I respectfully request that Camden rejects this application until such time that HS2 can clearly answer these questions. Please post this up as a response to application 2019/4700/HS2.

It's now been a fortnight since I asked you about lorry movements along the A41 in relation to your application 2019/4700/HS2

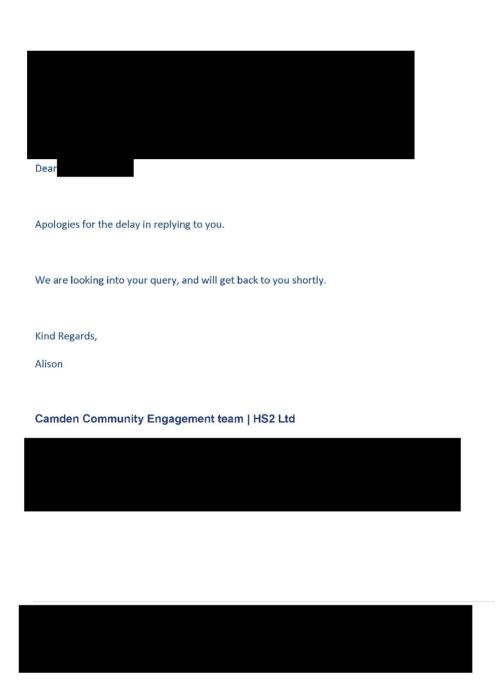
I repeat (with bold addition): <u>Do the number of vehicle movements of "540 -706 per day" as given in 3.7.43 of your Written Statement apply to the A41 north of Swiss Cottage gyratory and the gyratory section of Adelaide Road? If not, what would the numbers for the A41 be?</u>

If the vehicle movements "going into and out of the worksite" will be less than the numbers along the A41 north and of Swiss Cottage gyratory and the gyratory section of Adelaide Road, where would the rest of the vehicles coming out of the Adelaide Road Worksite go?
